**BEFORE THE PUBLIC UTILITY COMMISSION
OF OREGON**

Docket No. LC 80

PORTLAND GENERAL ELECTRIC COMPANY,

OPUC Staff Round 2 Comments and
Recommendations

Figure 2. Addendum Preferred Portfolio Annual Position (2030)

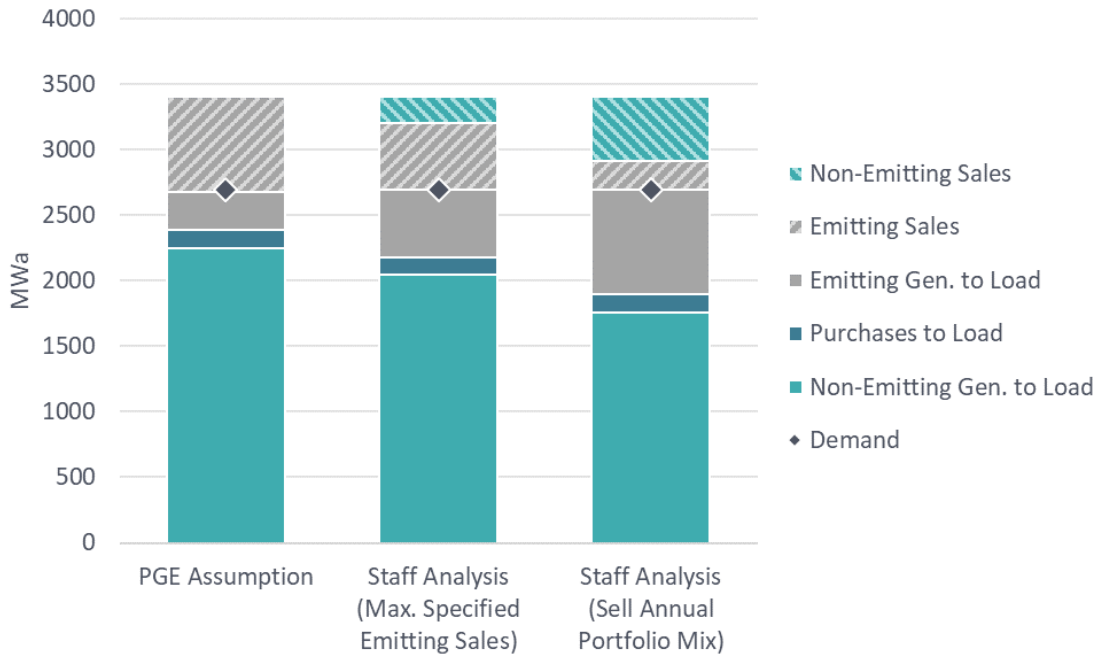
Staff finds that PGE’s approach overestimates both the Company’s ability to deliver non-emitting generation to load and its ability to sell emitting generation into the market, resulting in underestimation of its DEQ reported emissions. If PGE does not specify its sales, Staff’s analysis suggests that 485 MWh of the annual sales in 2030 would be assigned a zero emissions rate and 221 MWh would be assigned emissions rates associated with PGE’s natural gas generation for the year, per DEQ accounting rules. If PGE is able to specify the sales and maximize sales of emitting generation into the market, Staff’s hourly analysis identifies a physical limit to how much emitting generation can be sold in 2030 while still meeting load under typical weather conditions. Staff estimates that in this scenario, 507 MWh of PGE’s sales would be specified natural gas sales and the remaining 199 MWh of sales would be specified non-emitting. In contrast, PGE’s GHG calculations assume that all non-emitting generation is delivered to load and all sales are therefore specified emitting generation. Staff finds PGE’s assumption to be infeasible with the Preferred Portfolio in 2030.
